Register Reference : 91A/0751

DEVELOPMENT : Demolition and replacement of existing bungalow and  
septic tank on same site.

LOCATION : Tallaght Road near Wellington Lane, Templeogue

APPLICANT : C.A.G. Construction

4 MAY 92 11:50 1:50 16 7181  
SETTABLE AT TALLENT RD. WALL  
TEMPERATURE SURVEILLING DETAIL  
FOR C&G CONSTRUCTION. DRAWING  
NO. 7.1  
MILTON BRONN ARCH. ARCHITECTS  
1. Gungahlin Rd. Blackwood, C.A.

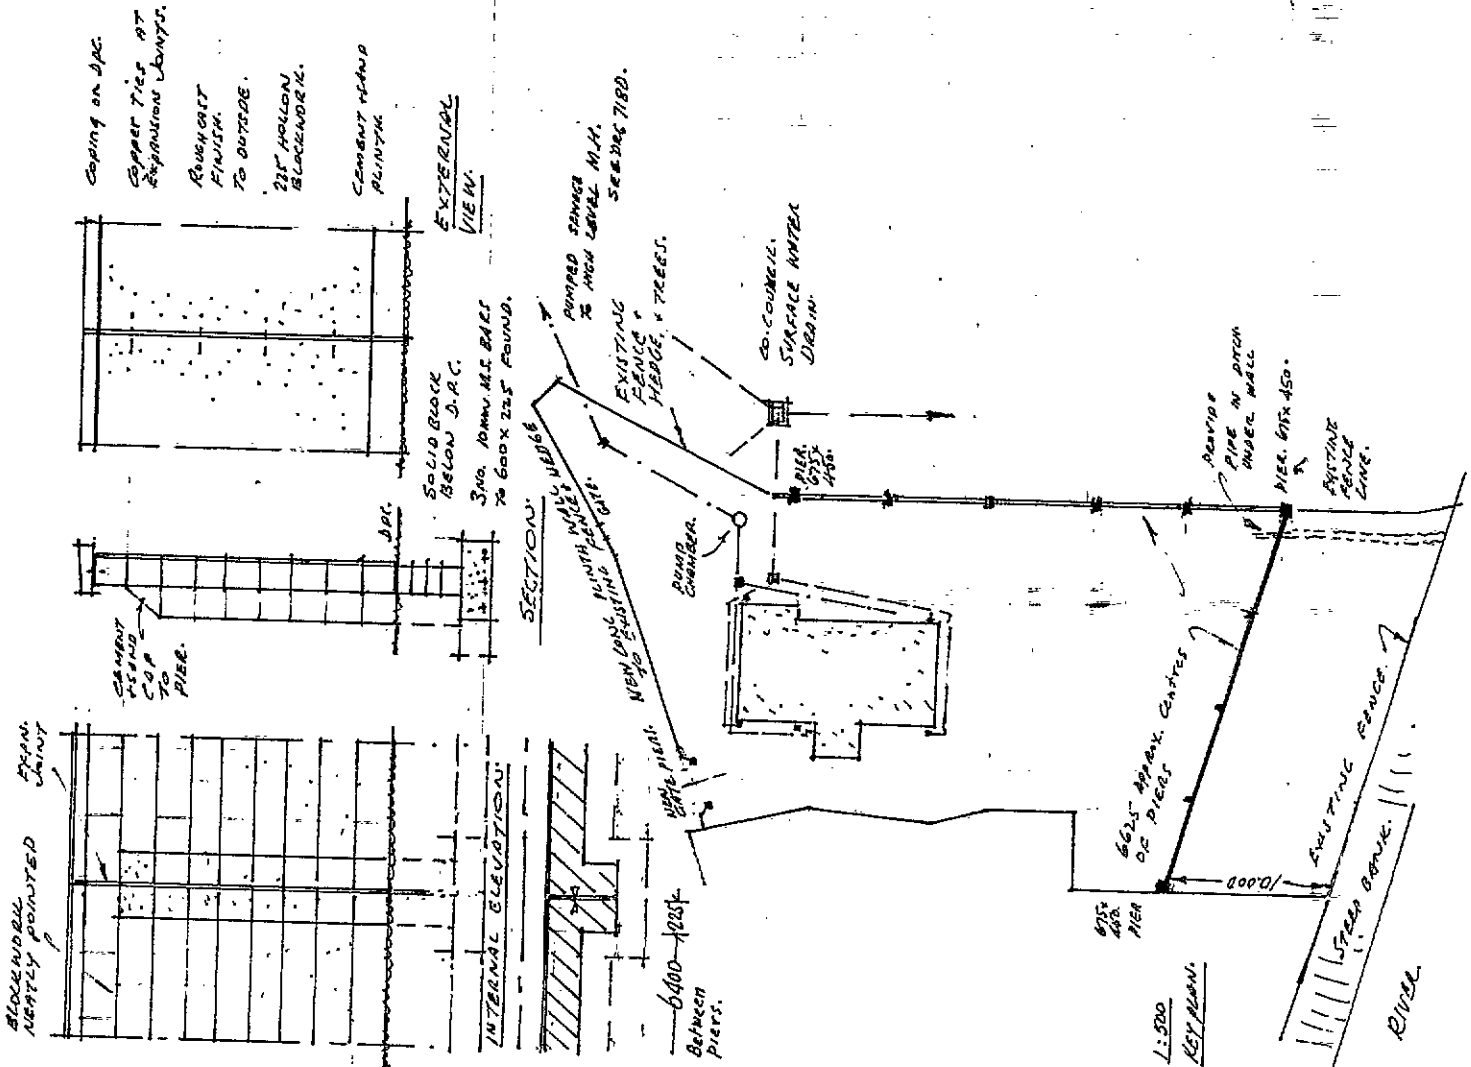
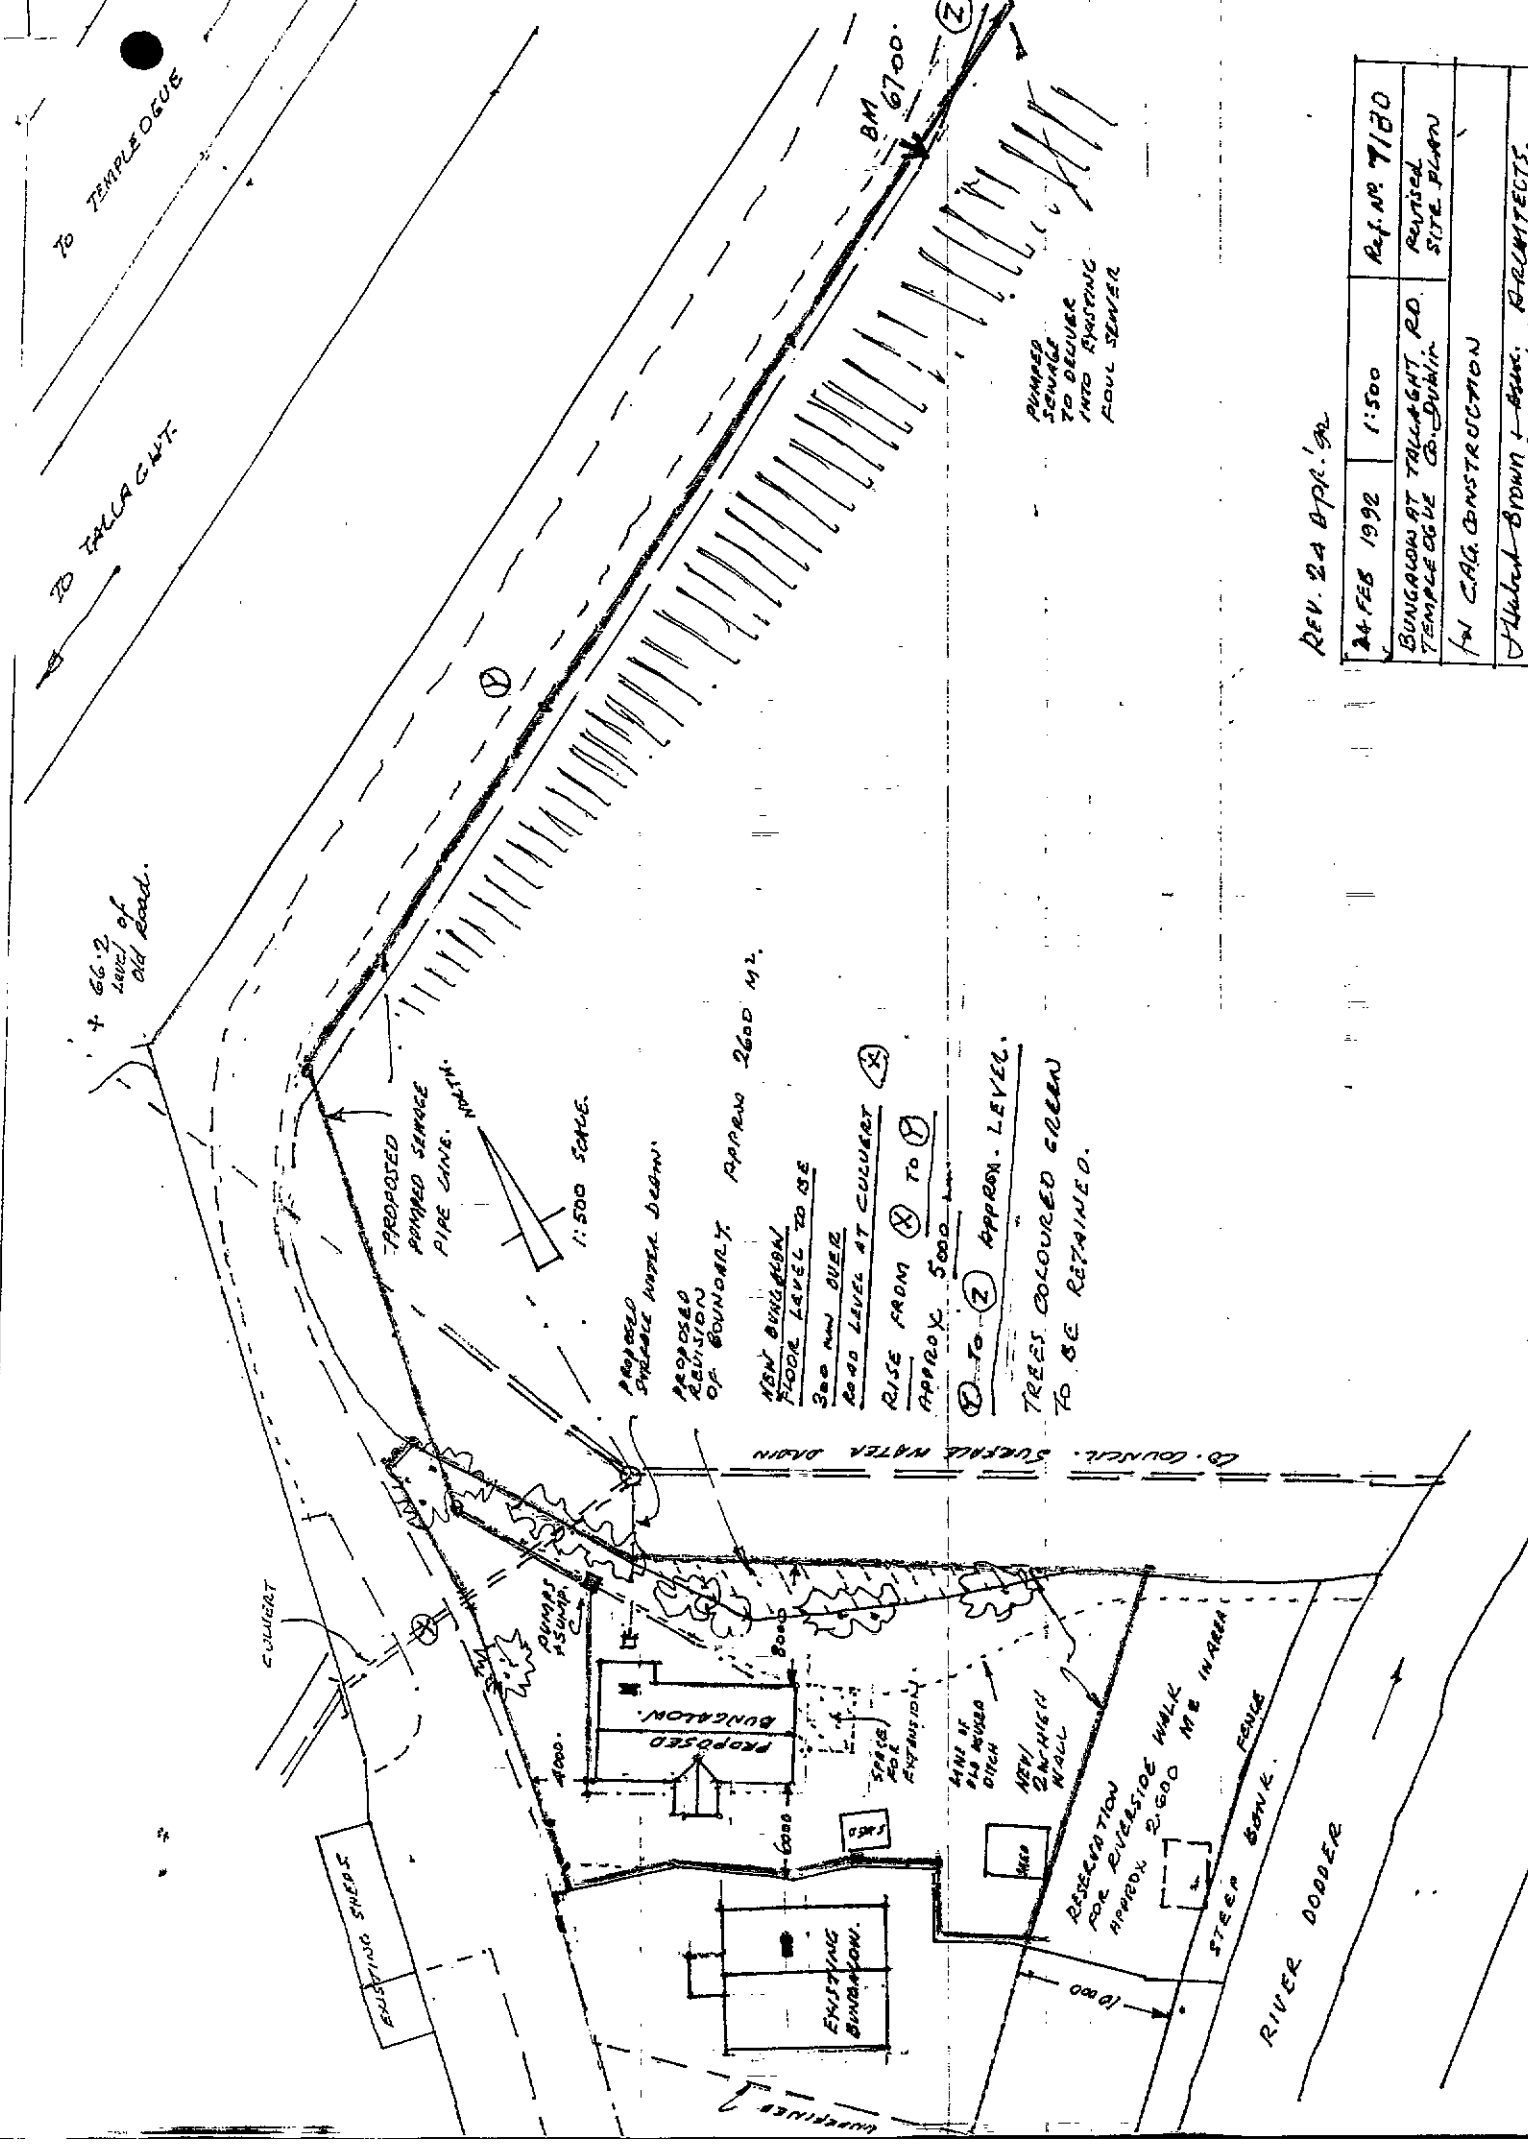
TO BE 100 MM PVC PIPES  
Laid on CONC. BED TO A  
DEPTH OF 1 IN. TO + TO BE  
ENCASED IN CONCRETE  
WHERE REQUIRED.

SEWAGE PUMP TO BE SUPPLIED  
FIXED BY SPECIALIST FIRM  
COMPRISING TWIN 'PARANA'  
TYPE PUMPS IN PREFABRICATED  
SUMP SET ON + SURROUNDED  
WITH 150 MM CONCRETE COVER.

AFFLUENT TO DELIVER TO  
NEAREST Foul SEWER + TO  
CONSIST OF 50 MM WAVIN PIPING  
THREADED THROUGH 100 MM PVC  
SEWER GRADE PIPING WITH  
ACCESS POINTS AS SHOWN.

TO BE 100 MM PVC PIPING  
SET ON LEAN MIX BED  
HOUNCHED UP WHERE REQ'D  
+ TO DELIVER TO COUNTY  
LAUNDRIC DRAIN AS SHOWN.

24 FEB 1992	1:500	REF. NO. 7180
BUNGALOW AT TALLAGHT, RD. TEMPLE OGUE CO. DUBLIN		REVISED SITE PLAN
IN CLG. CONSTRUCTION		
Hubert BROWN + ASSOC. ARCHITECTS

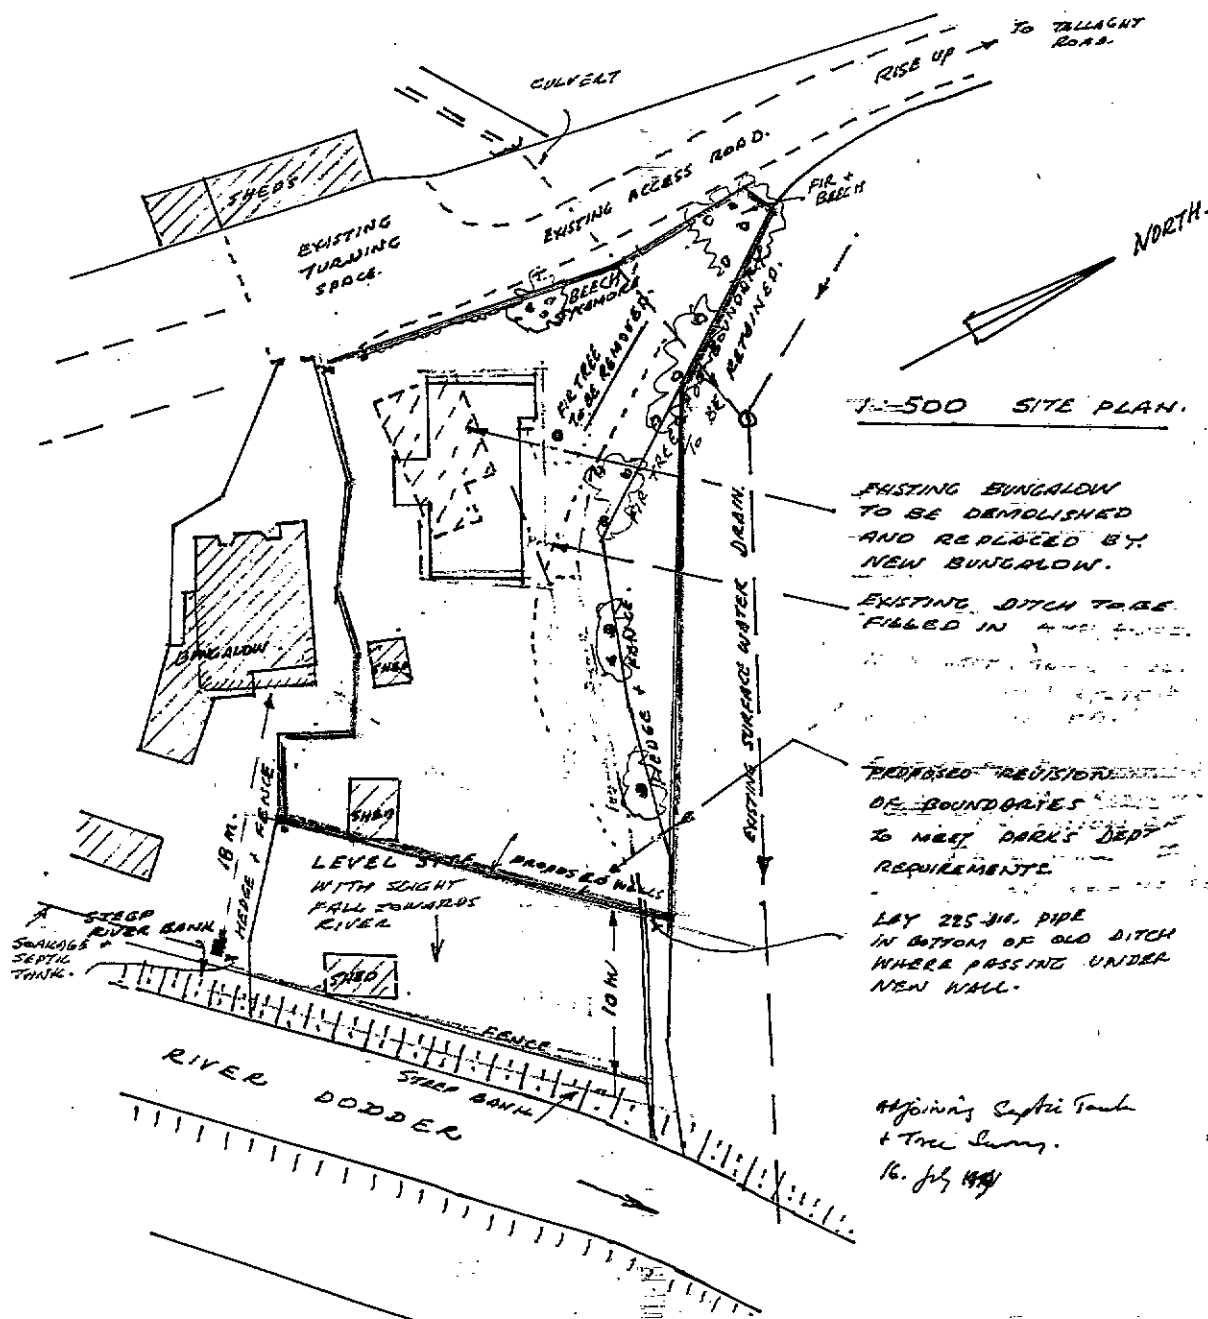
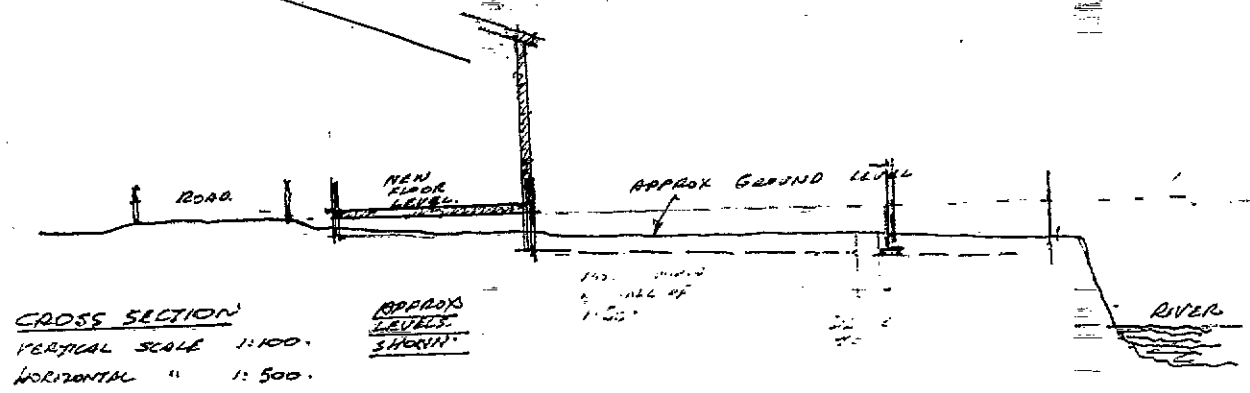
1. Drainage: The soakage test having proved to be unsatisfactory, it was agreed in principle by the Drainage section that pumped effluent to a foul sewer would be considered. A revision of boundaries was also agreed tentatively with the Parks dept. to provide a riverwalk at the rear of the site. These revisions have been shown on the revised drawings enclosed.

PROPOSED REVISIONS OF BOUNDARIES TO MEET DAK'S DEPT REQUIREMENTS

LAY 225-MM PIPE IN BOTTOM OF OLD DITCH WHERE PASSING UNDER NEW WALL.

1:2500 SITE PLAN.

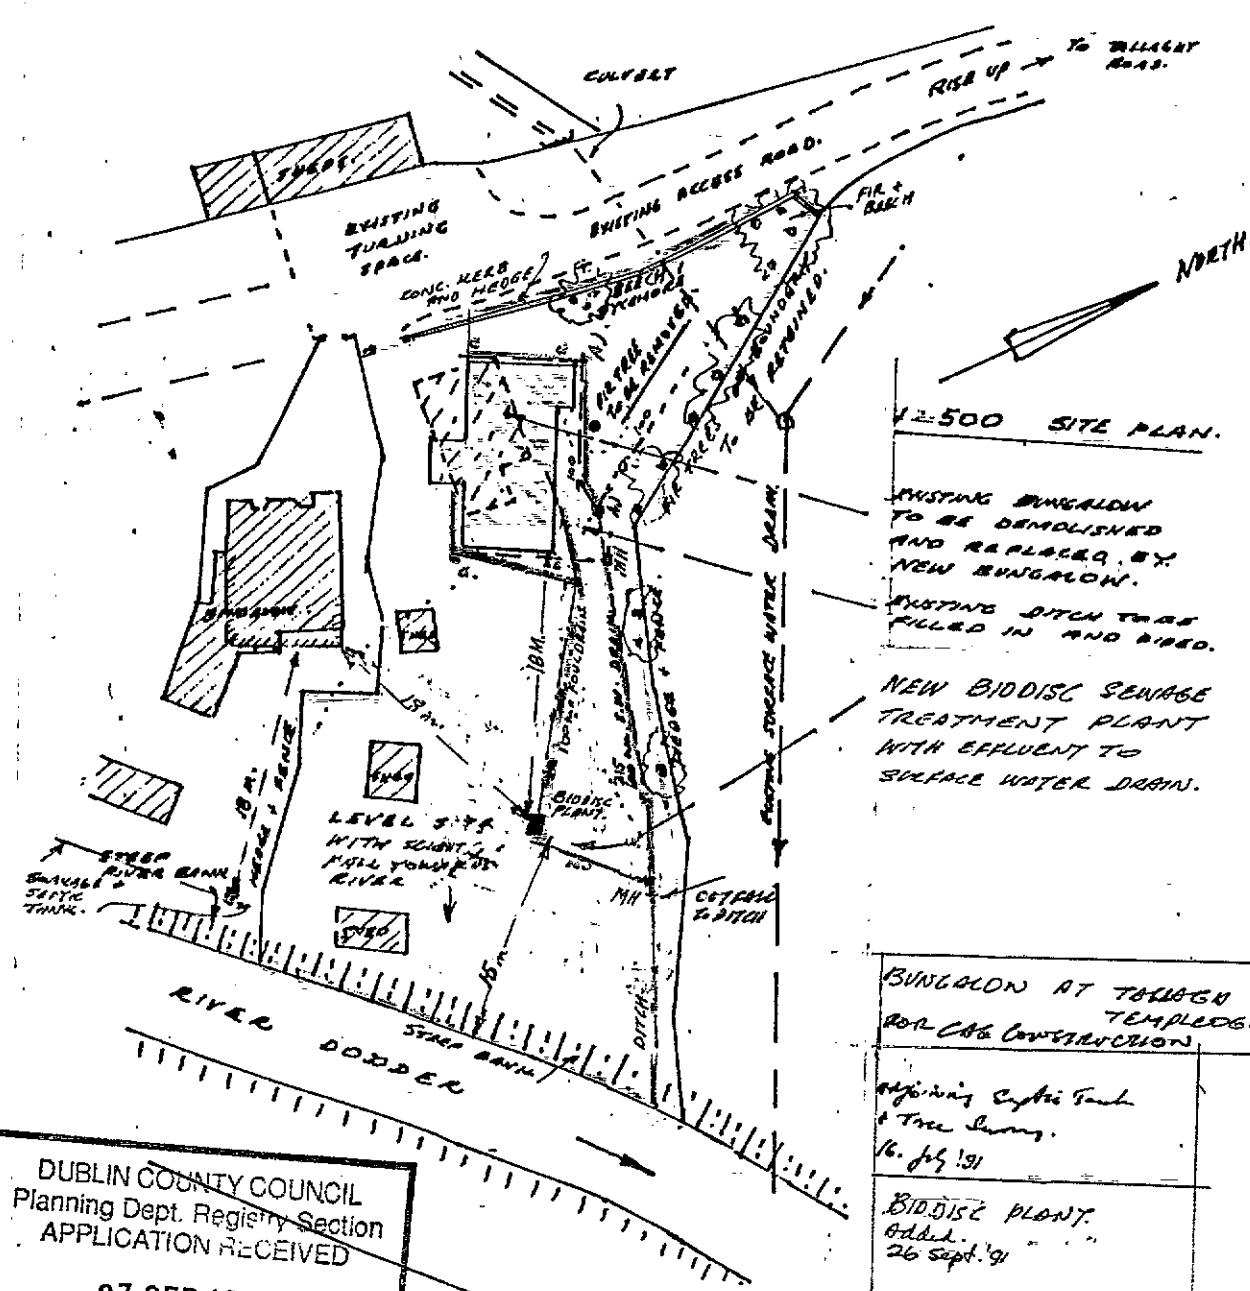
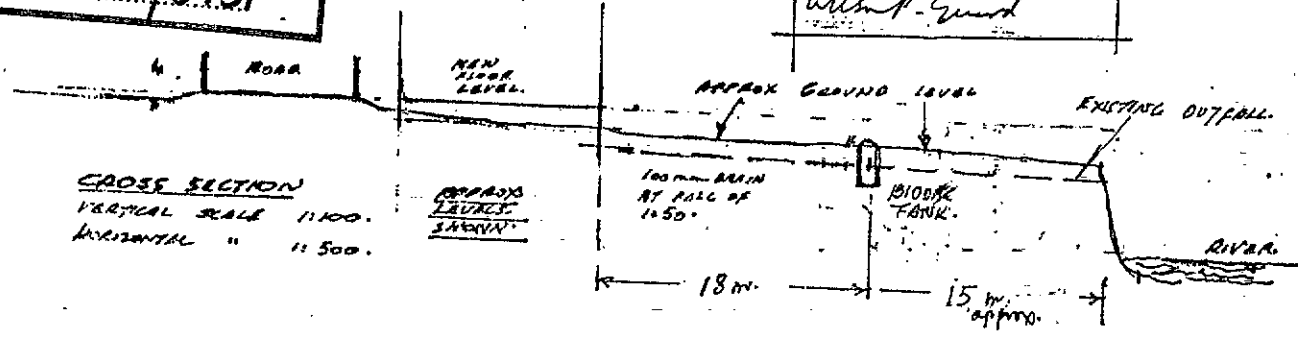
- (2,3,4) Drainage: Our Client has had tests for suitability of the site for the standard septic tank detail, carried out by Site Investigation, Newcastle, Co. Dublin. The recorded soakage proved to be unsatisfactory and we are now proposing the use of a Biodisc tank as an alternative to the standard tank. We attach details of this system. We would be glad to discuss outfall arrangements on having the Council's acceptance of this system. Areas for percolation would not be required. See letter to Planning.

EXISTING BUNGALOW TO BE DEMOLISHED AND REPLACED BY NEW BUNGALOW.  
 EXISTING DITCH TO BE FILLED IN AND BARRED.  
 NEW BIODISC SEWAGE TREATMENT PLANT WITH EFFLUENT TO SURFACE WATER DRAIN.
